**TOWN OF MOUNTAIN VILLAGE
REGULAR DESIGN REVIEW BOARD MEETING
AGENDA**

THURSDAY OCTOBER 1, 2020 10:00 AM

TO: Mountain Village Design Review Board
FROM: John Miller, Senior Planner
FOR: Design Review Board Public Hearing; October 1, 2020
DATE: July 23, 2020, *Updated September 18, 2020*
RE: Staff Memo – Final Architecture Review, Lot 630

1 ROOF HEIGHT DIAGRAM
SCALE: 1/4" = 1'-0"

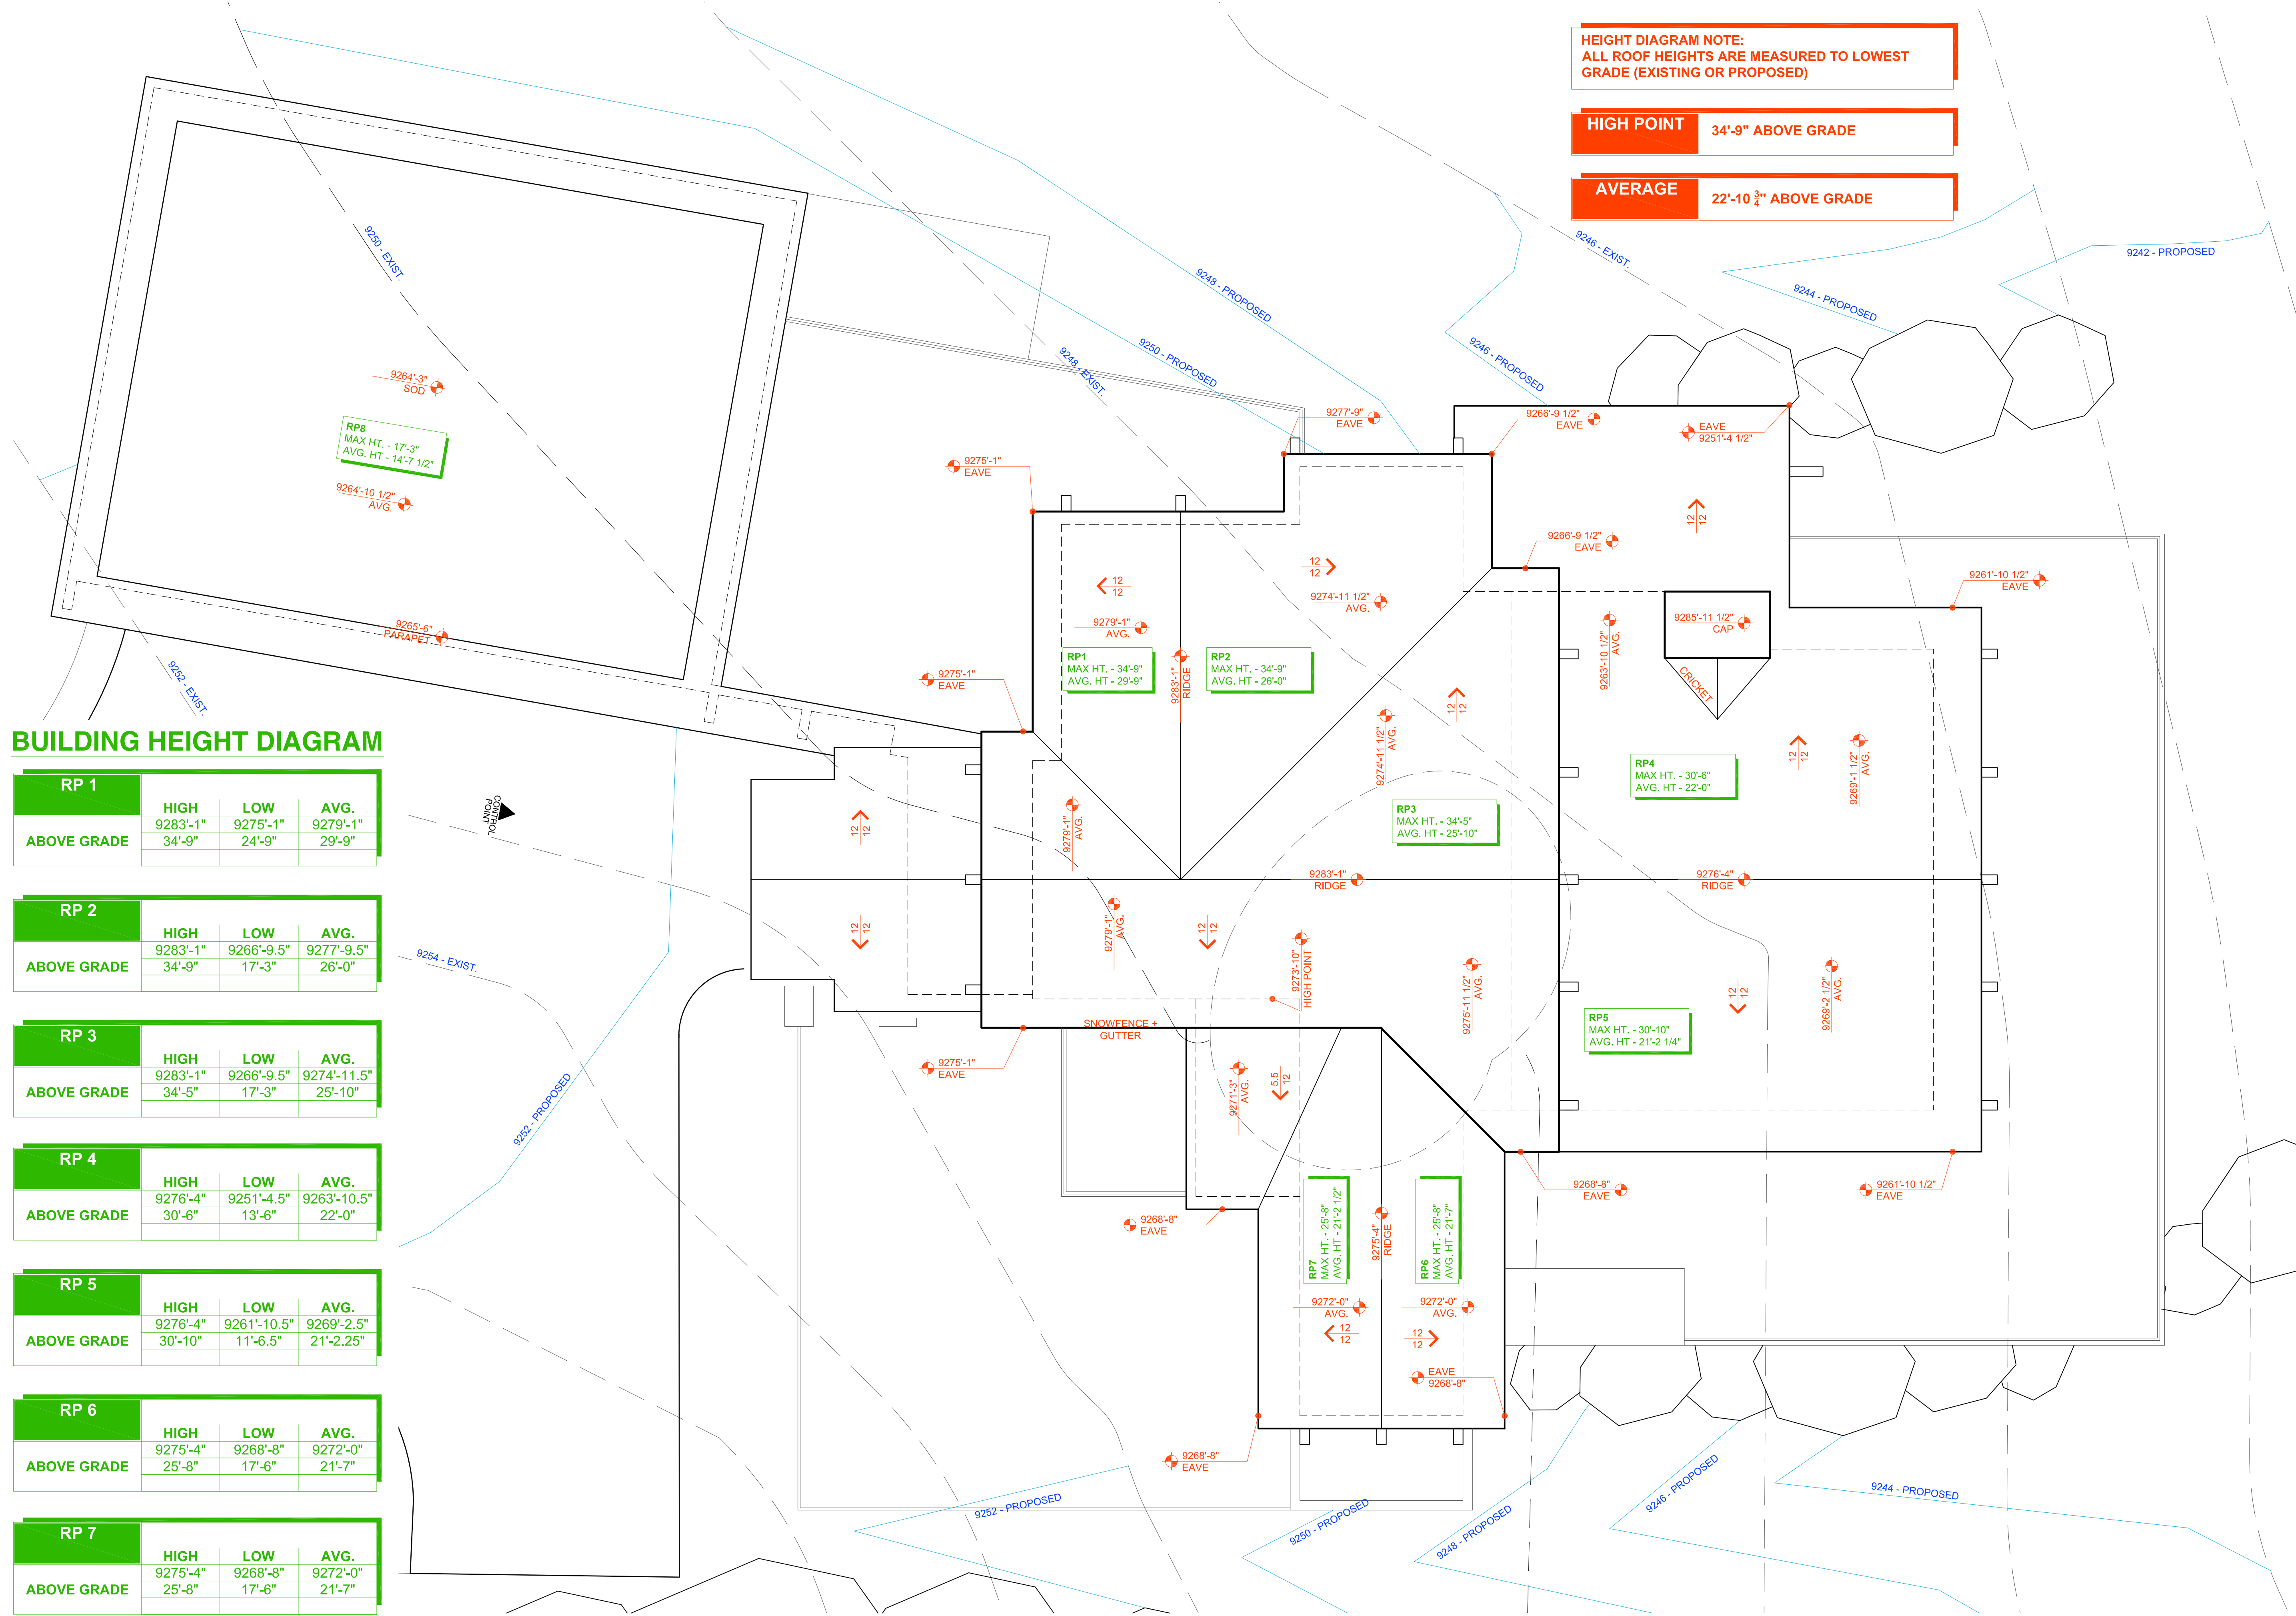
Staff: Since the August IASR, the applicant has revised both the Maximum Building Height and the Average Building Height Analysis' to address staff concerns detailed in the August memo. Based on the elevations provided, the maximum height for the structure is 34' – 9" from the highest ridge to the most restrictive grade. The applicant has provided a parallel plane analysis demonstrating that no portion of the home penetrates the 40-foot parallel slope height allowance. The average height calculations have been revised since August based on staff's comments, and the analysis appears to now be compliant with the CDC requirements for both maximum height and maximum average height.

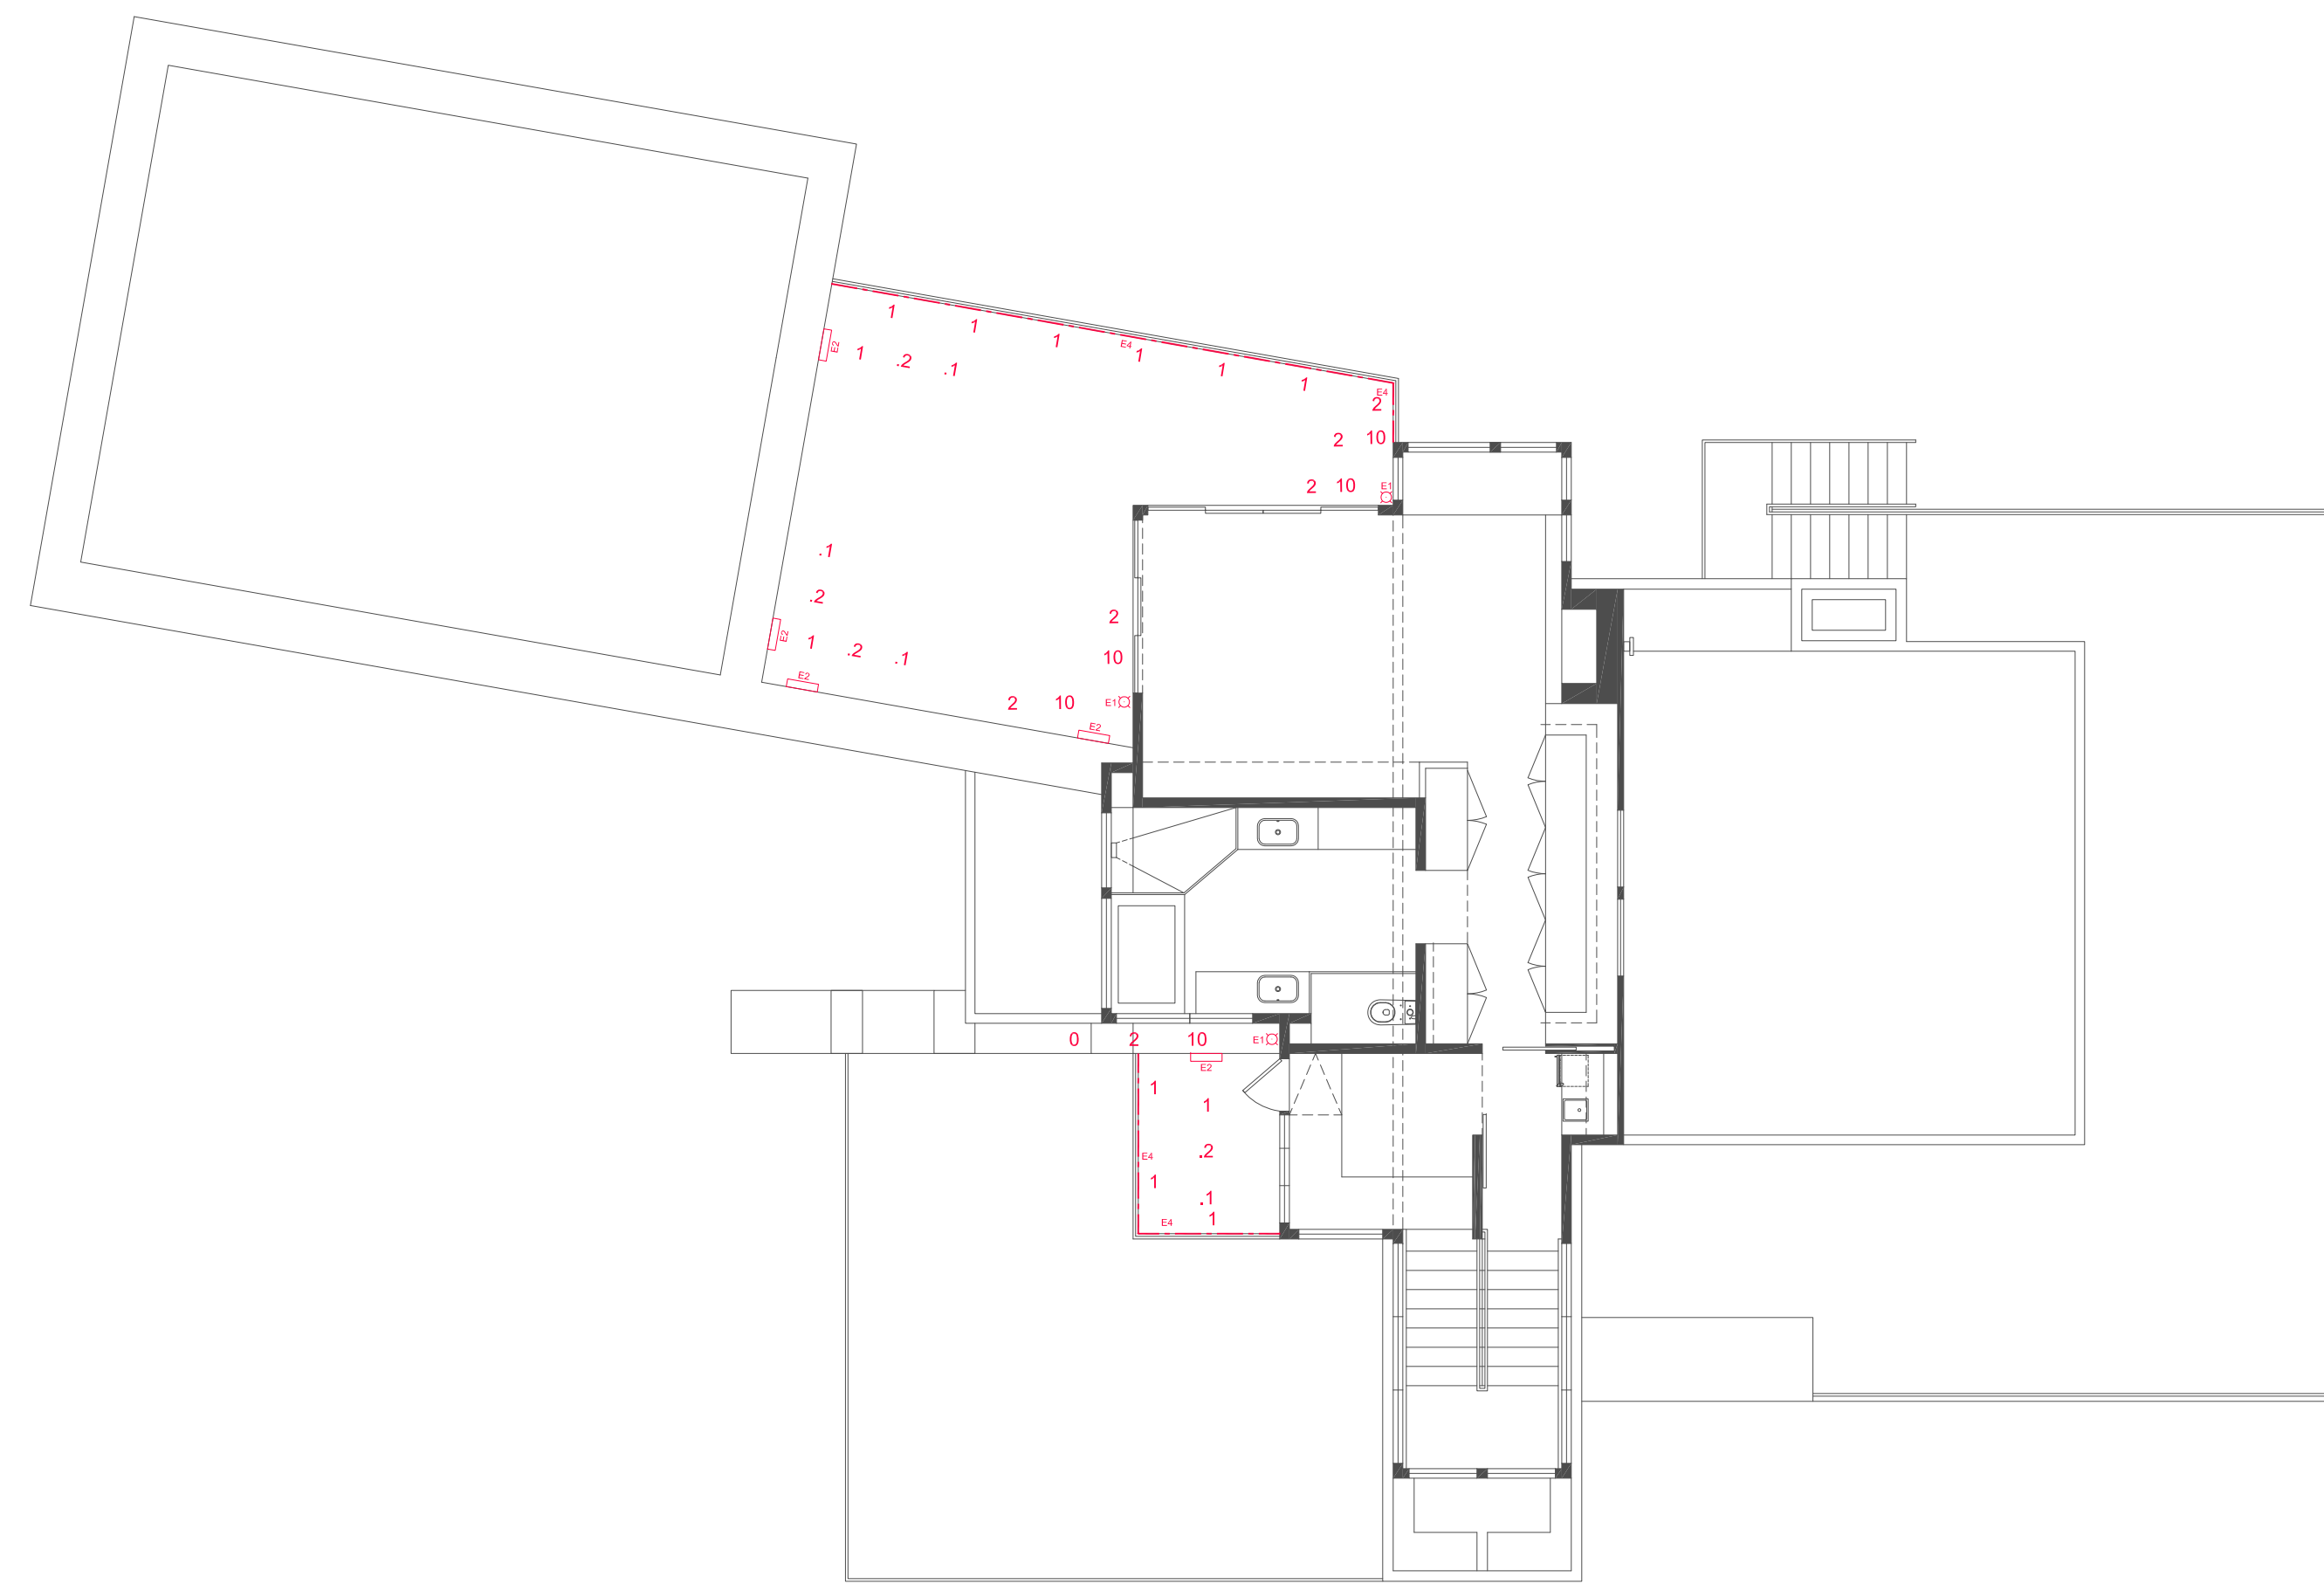
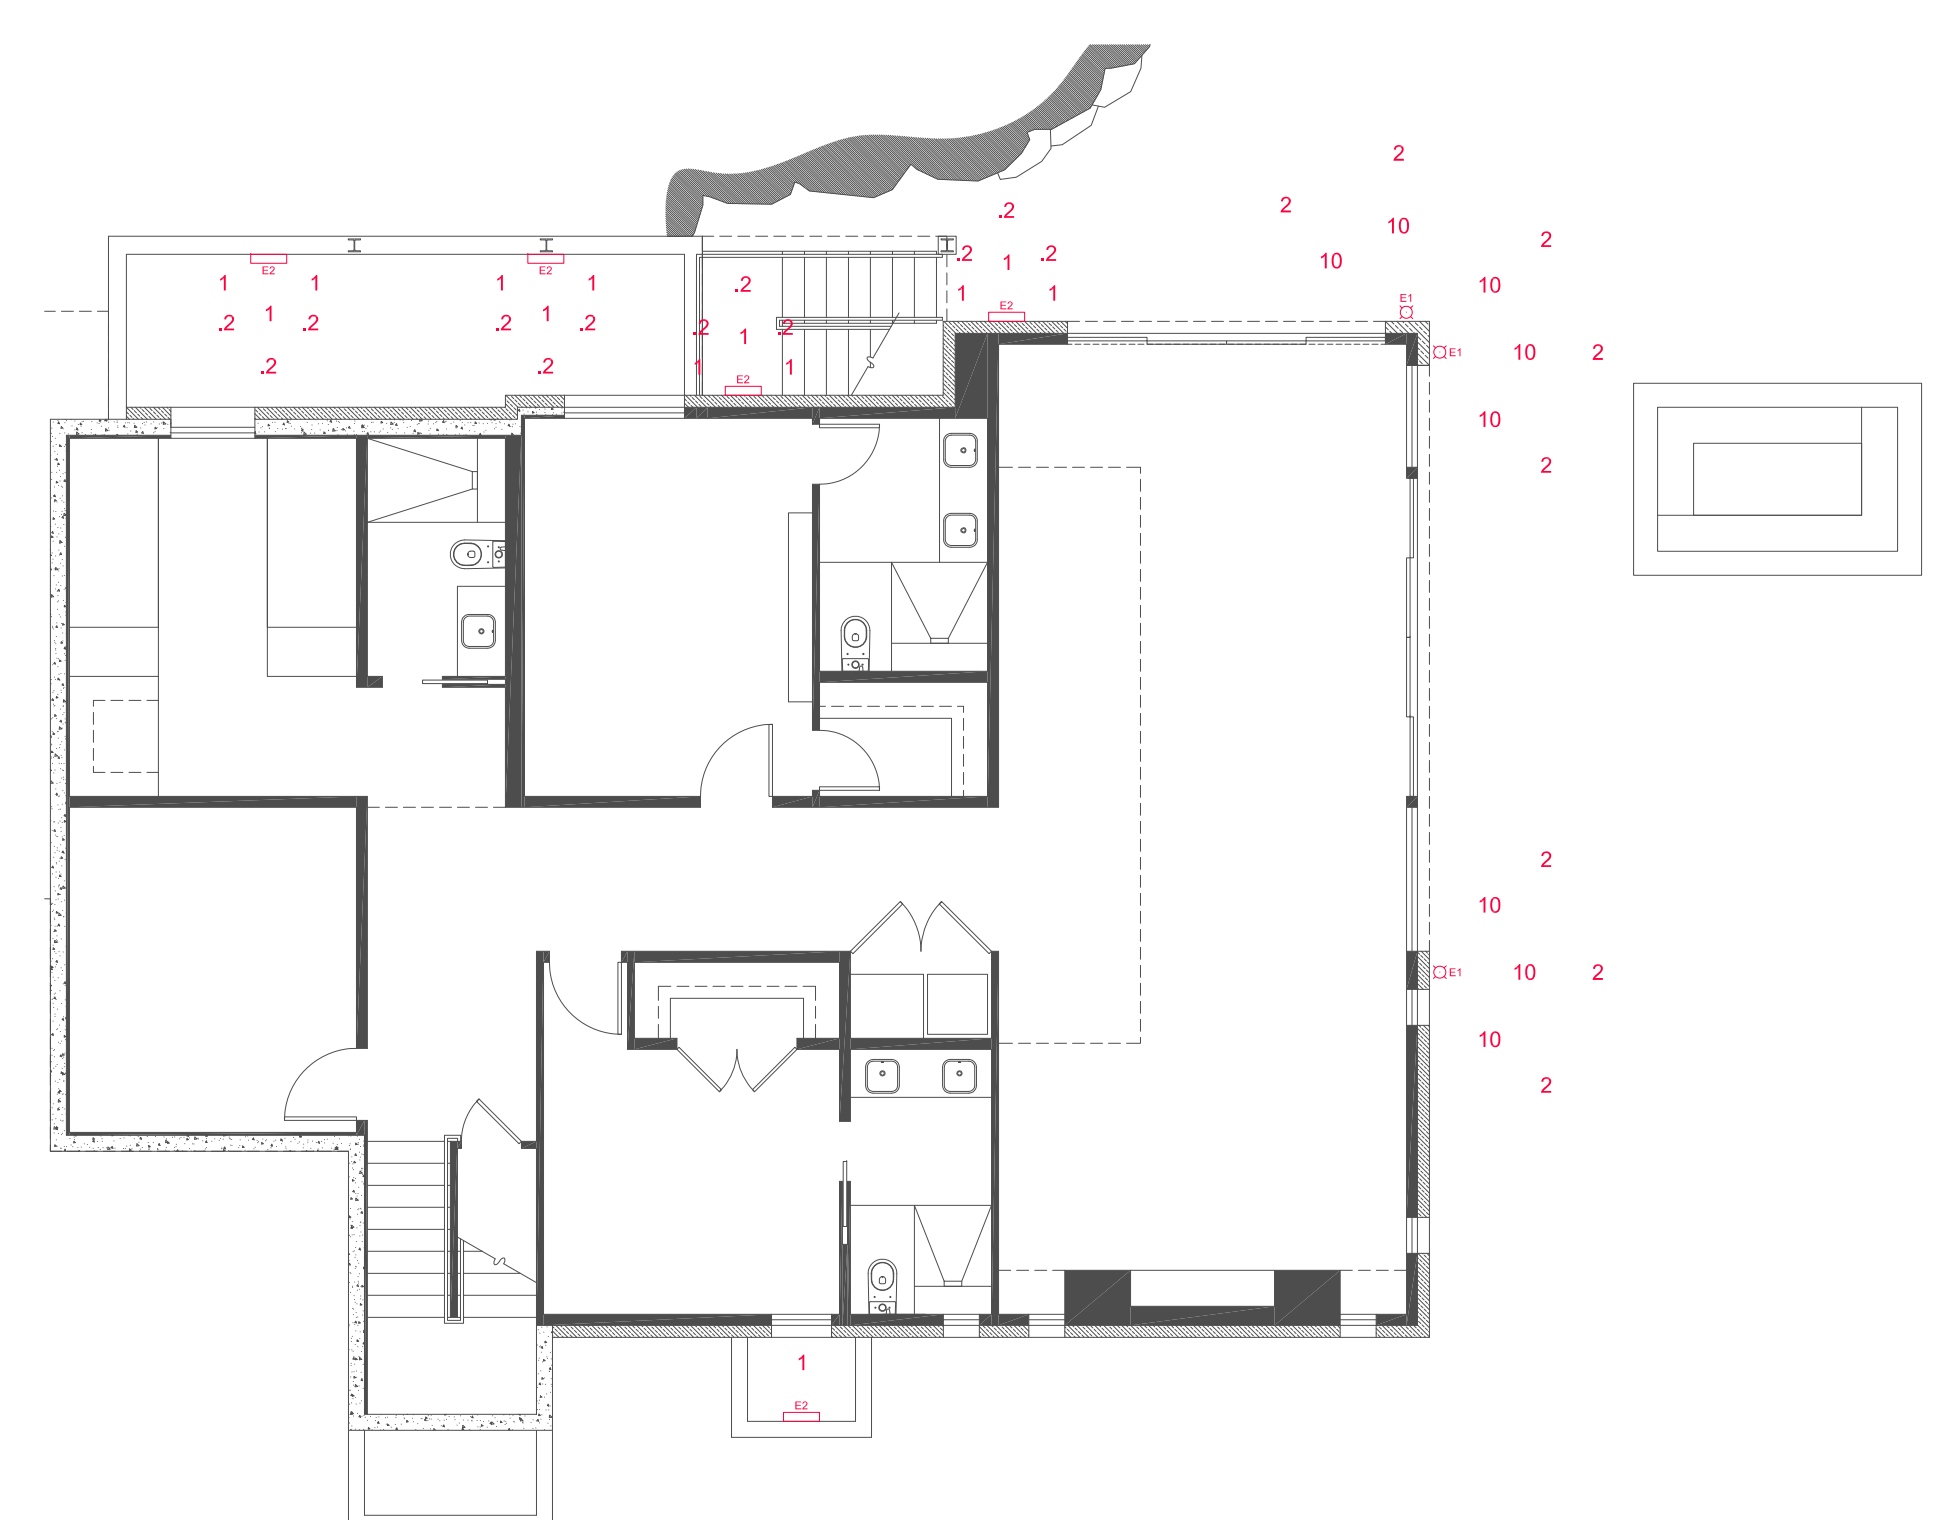
Staff: The applicant has provided an updated lighting plan since the September IASR reducing the overall number of fixtures requested. They have additionally provided additional information including specific cutsheets as well as a foot-candle study. Based

on the updated plans, the DRB may still want to request additional lighting changes that would subdue the lighting of the home. Two of the fixtures exceed the total lumens per lamp permitted. This would require either a dimmer to operate these fixtures permanently or a revision to the proposed fixtures. Staff suggests that the DRB condition a final lighting plan to be approved by staff and a member of the DRB to address total lighting levels, fixtures, and dimming options.

- 1) Prior to the issuance of a building permit, the address monument must be revised to demonstrate dry stack rock arrangement to match the home.
- 2) Prior to the issuance of a building permit, the applicant shall provide an updated lighting plan to be reviewed and approved by staff and a member of the DRB.
